ISSUE: Permit to Demolish/Capsulate (partial) and Certificate of Appropriateness

APPLICANT: Demaine Funeral Home

520 South Washington Street

Docket #6&7 BAR #2023-00486 & 2023-00487 Old and Historic Alexandria District December 20, 2023

Figure 5. Proposed east elevation showing the design of the pedestrian and vehicular doors, bollards, and lighting.

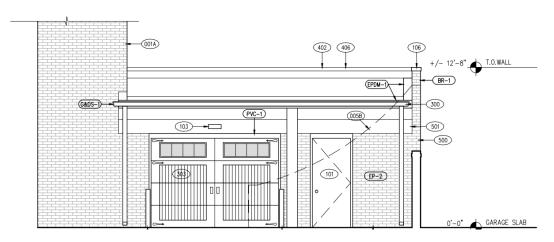
On the east elevation, after demolishing the masonry staircase, the applicant proposes to create openings for a new pedestrian door and vehicular garage door (Figure 5). The garage door will be a Clopay Reserve wood style door with PVC trim. Both the door and trim will be painted to match the existing trim. The pedestrian door will be a flush style wood door painted to match the adjacent masonry wall. Additionally, there will be two stainless steel bollards flanking the garage door, and an LED wall-mounted light fixture above the garage.

According to the *Design Guidelines*, "Exterior doors...constitute prominent visual details of the main façade of a building. In addition to the door itself, details surrounding the doorway are also important visual elements of a building...Exterior doors should complement the architecture of the structure and not detract from it." The proposed pedestrian and vehicular garage doors will be located on a modern addition and the proposed designs and materials are compatible with the architecture of the addition. Additionally, the doors will be very minimally visible from the public right of way. Overall, the proposed alterations will not have a significant impact on the history or integrity of Demaine Funeral Home.

Staff therefore recommends approval of the Certificate of Appropriateness for alterations, with the condition that the applicant work with Staff to choose an appropriate design for the light fixture above the garage door.

Figure 8. The project area is separated from the public right of way by a large private surface parking lot.

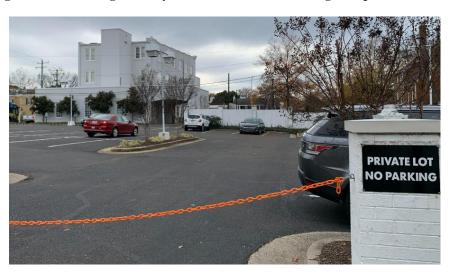
Figures 7 and 8 below show the minimal visibility of the alterations when standing on South Saint Asaph Street.
